ARCHITECTURAL ACCESS BOARD- HEARING PACKET

Name	Salem YMCA	Docket #	V 25 - 089		
Address	1 Sewall Street	Docket #	C -		
City	Salem	Hearing	8/24/2026		
Bldg Type		Time of hearing	11:00 AM		
Complaint's Name		Plans on file?			
Complaint ?	Variance ?	Request for continuance?			
Jurisdiction:	3.3.2	If the work performed amounts to 30% or more of the full and fair cash value of the building, the entire building is required to comply with 521 CMR.			
Building Permits:	Anticipated construction cost: \$3,500,000				
Assessed Value:	\$4,226,800

Exhibit: 1
V25-089
AAB 1-117

Petitioner seeks relief from: 26.6: A minimum clear floor area shall be provided on both sides of all doors and gates.

1 LEVEL 2 - FLOOR PLAN - EXISTNG & DEMO -
SCALE 1/4" = 1'-0"

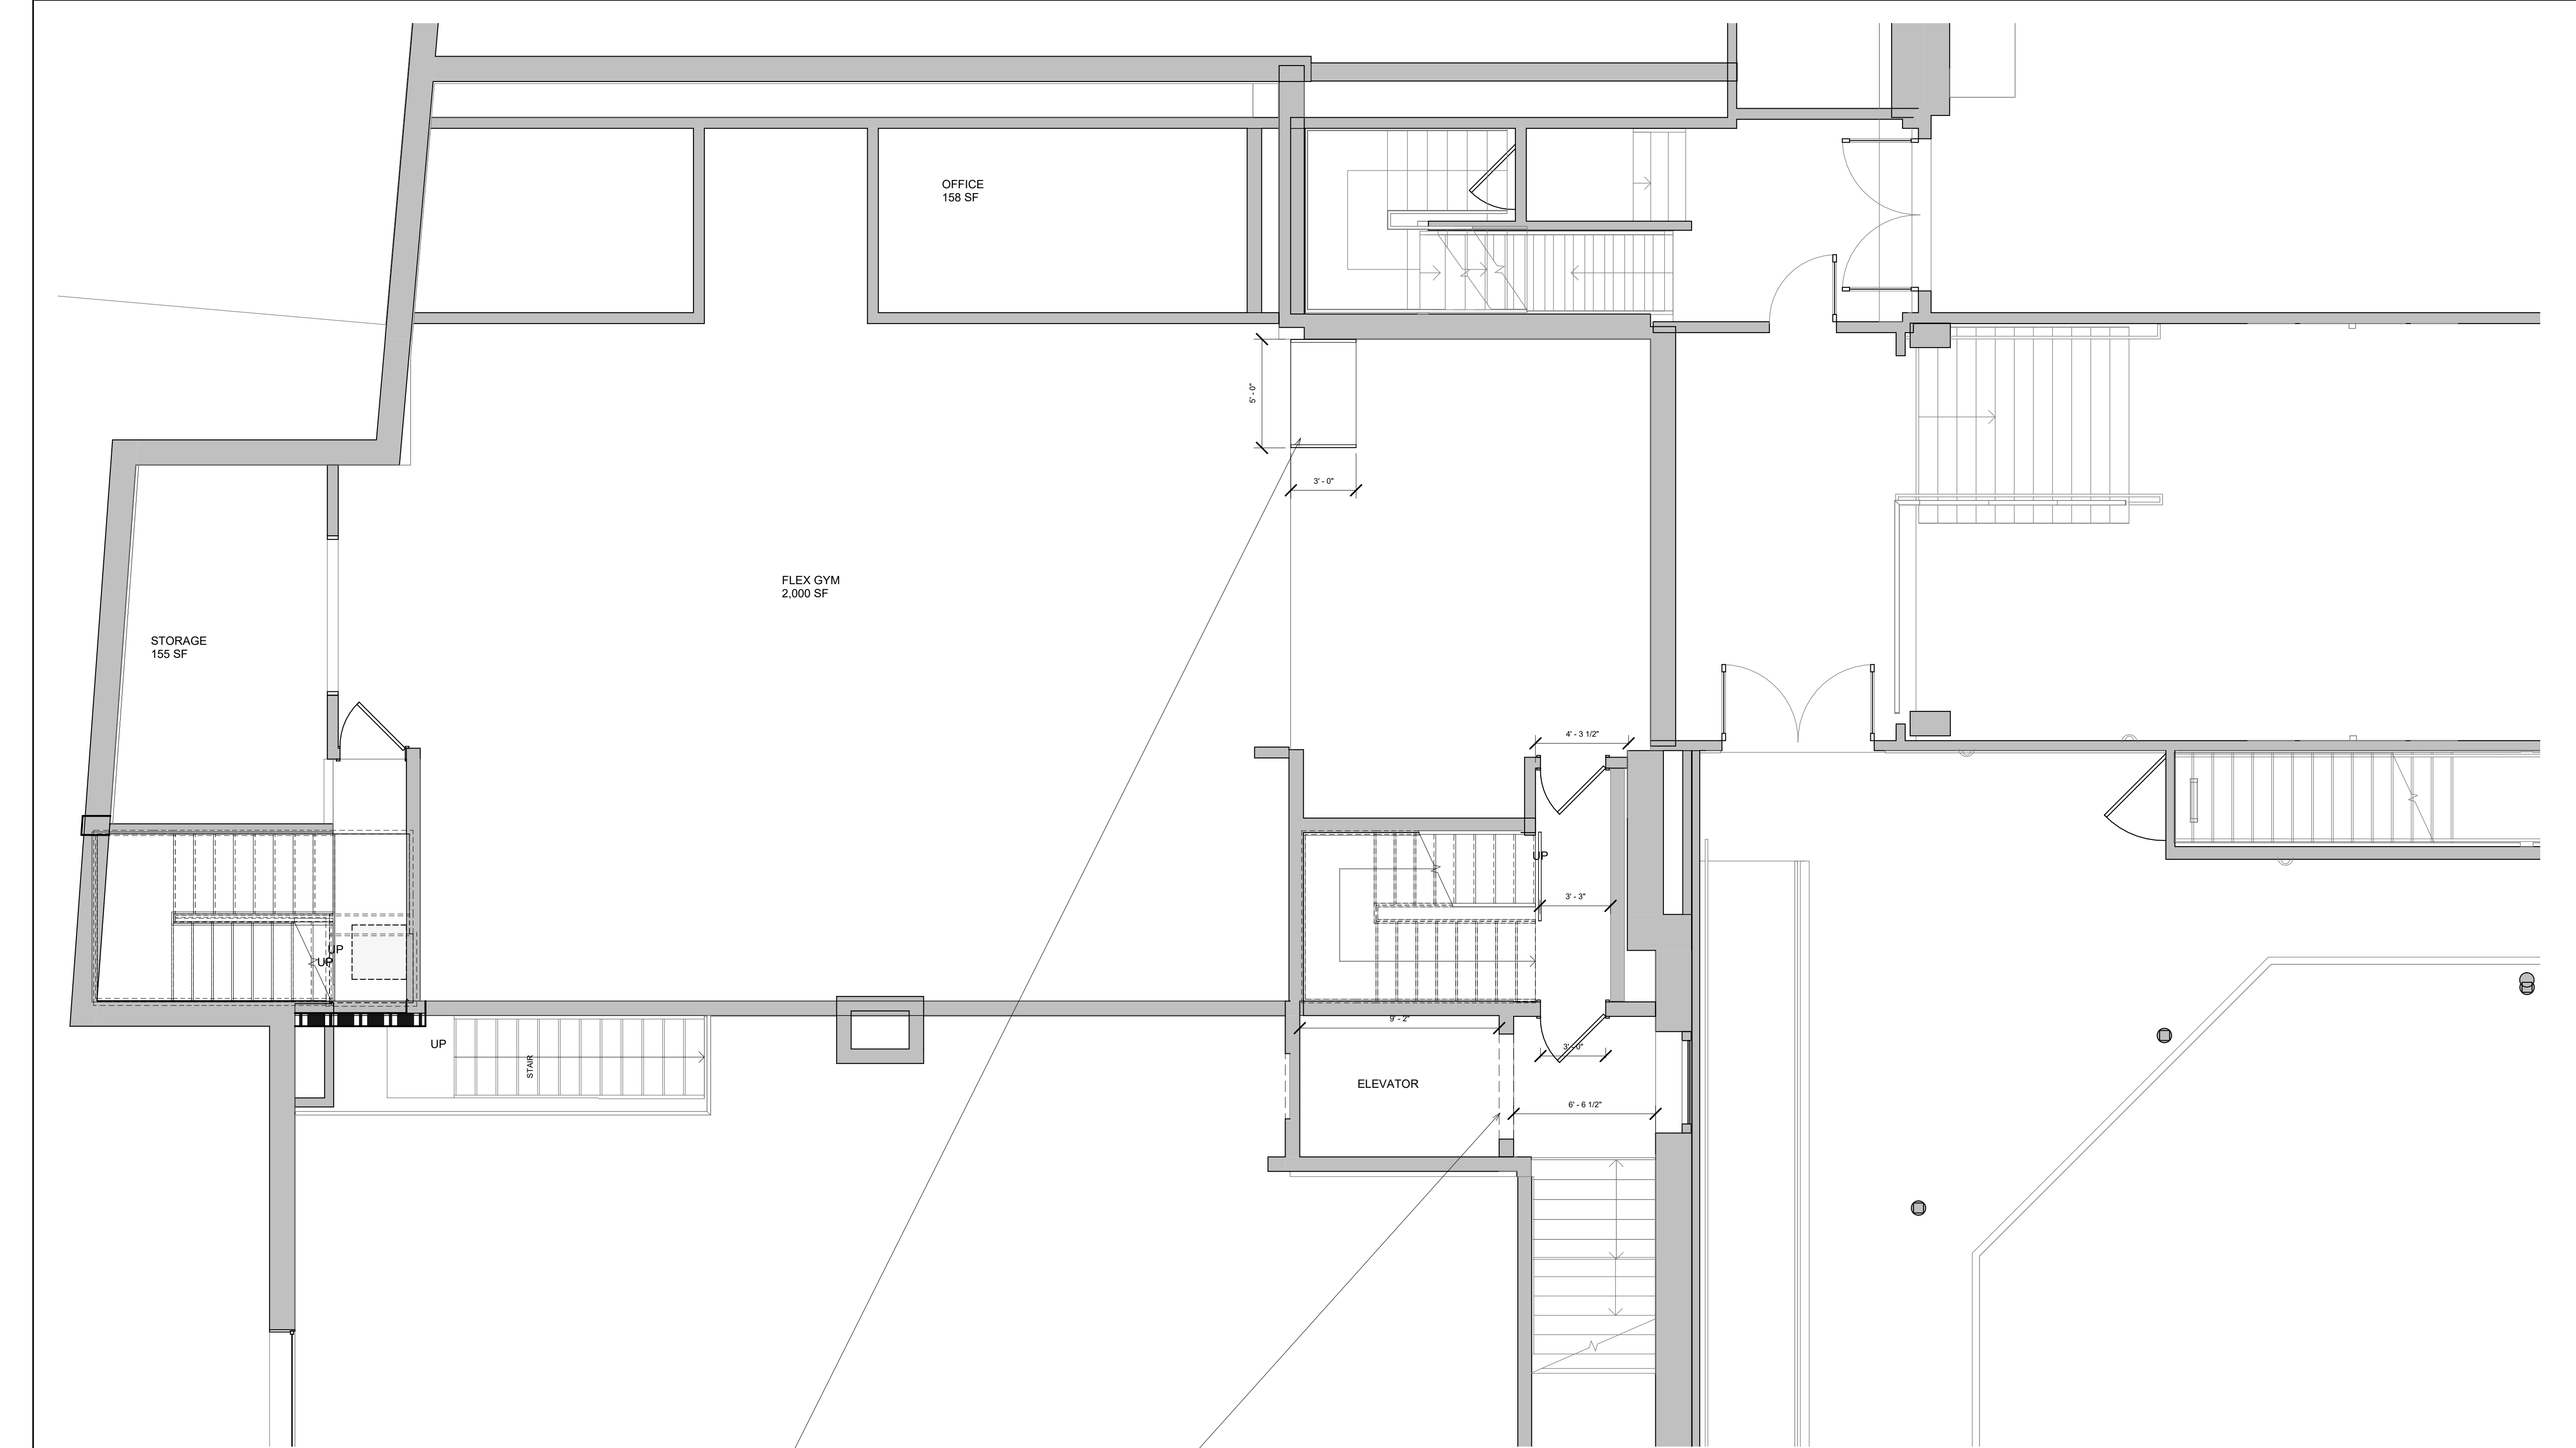
- to **CONTINUE** Petitioner's Request 2 for relief from 521 CMR 28.1 (elevator) and **ORDERS** Petitioner to provide the Board with: (1) test drawings for a permanent or portable lift; and, (2) the policy on moving programming to accessible spaces;

1. See Attachment C for test drawings to provide an accessible route to the flex gym space. Note that the scope of work includes (1) adding another stop to the elevator and opening the existing shaft wall and (2) construction of a new ramp to access the space.
2. See Attachment A for the written policy for relocating the special programming throughout the facility.
